ADDENDUM NO. 01

October 19, 2026

RE: Upper Leacock Township Municipal Authority
New Holland Pike Low-Pressure Force Main Replacement Project
Contract 2026-04
RETTEW Project No. 0571401439

DWG. NO. C-08

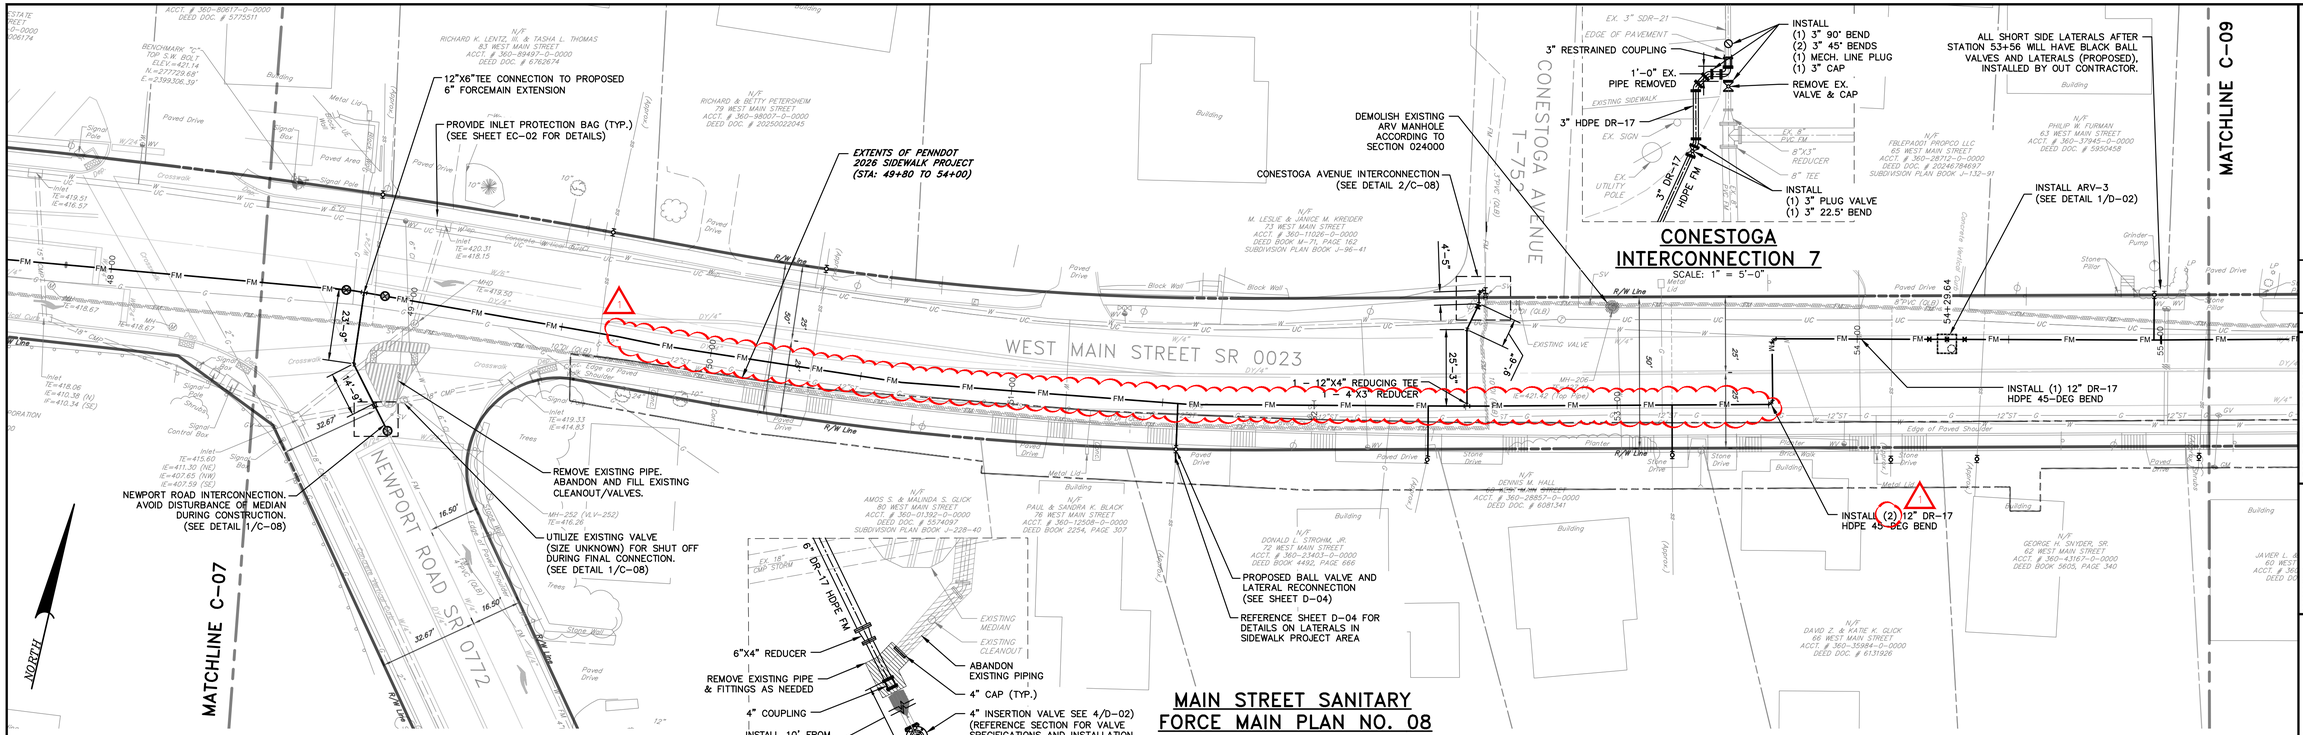
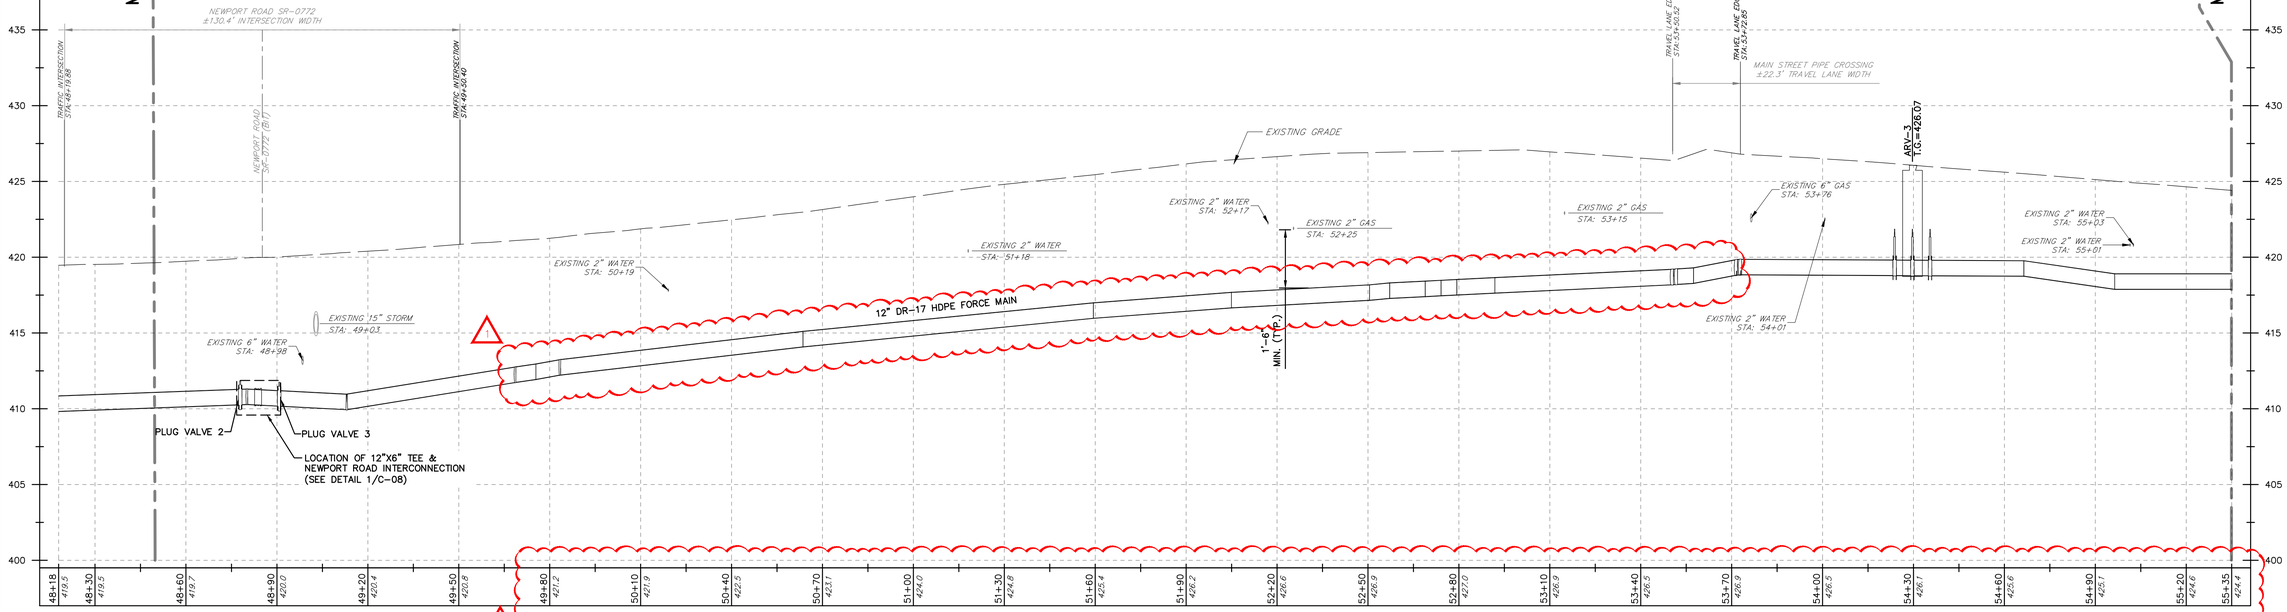
Delete Sheet C-08 and replace it with the revised sheet. The revised sheet eliminates the originally proposed force main alignment along the sidewalk and establishes the alternative alignment within the roadway travel lane as the required alignment for construction. The forcemain shall be installed in accordance with the revised Sheet C-08. Note that these changes were already reflected in the originally issued bid form quantities.

DWG. NO. EC-04

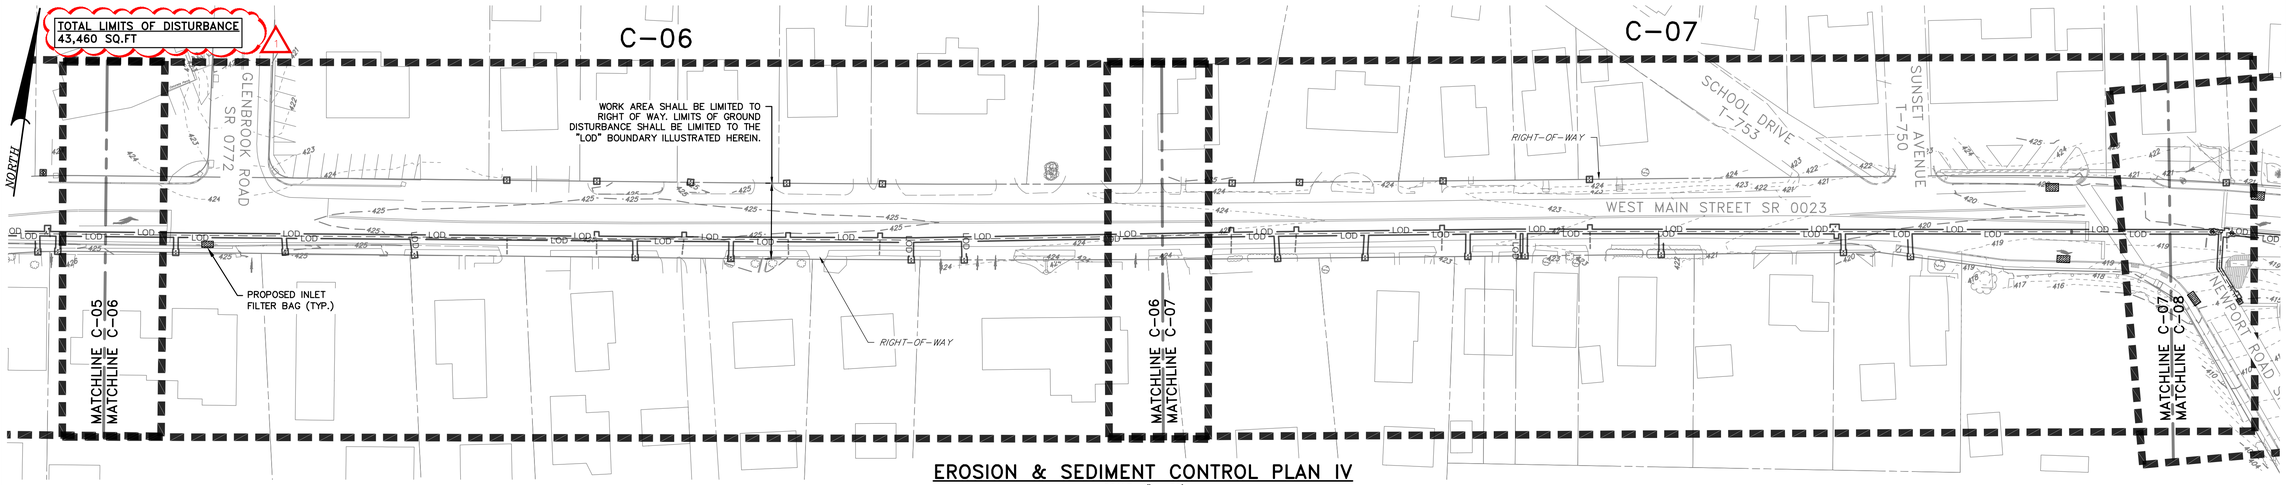
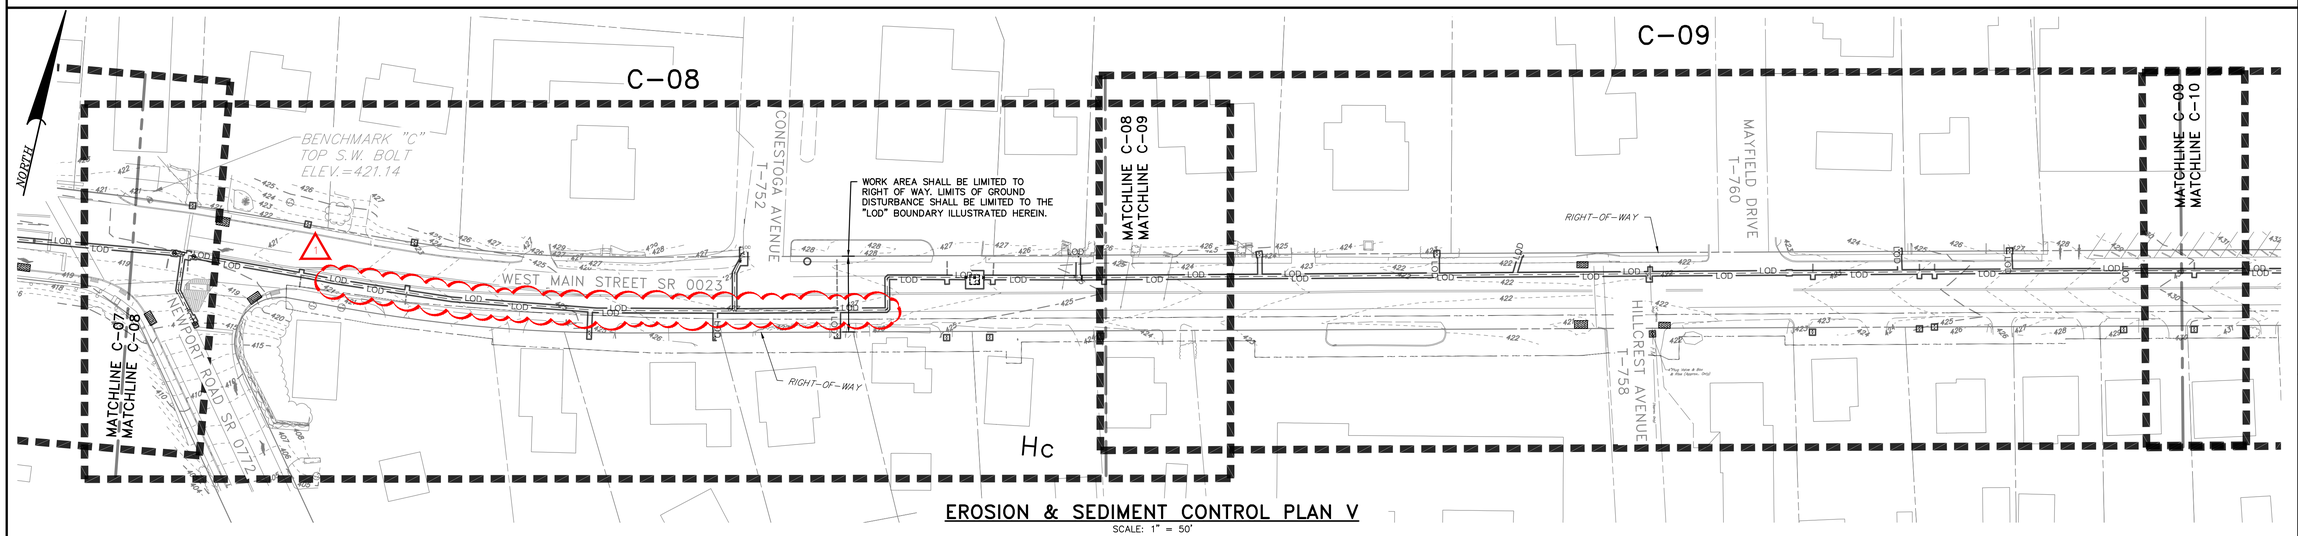
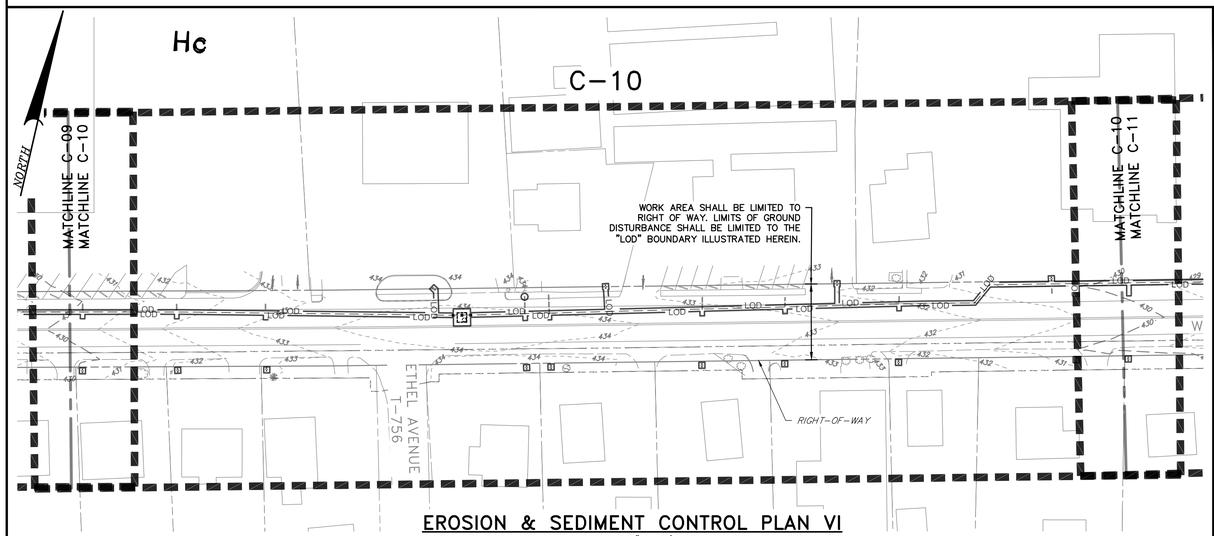
Delete Sheet EC-04 and replace it with the revised sheet. The revised sheet eliminates the originally proposed force main alignment along the sidewalk and establishes the alternative alignment within the roadway travel lane as the required alignment for construction. The forcemain shall be installed in accordance with the revised Sheet EC-04. The Limit of Disturbance has been updated to indicate the changes.
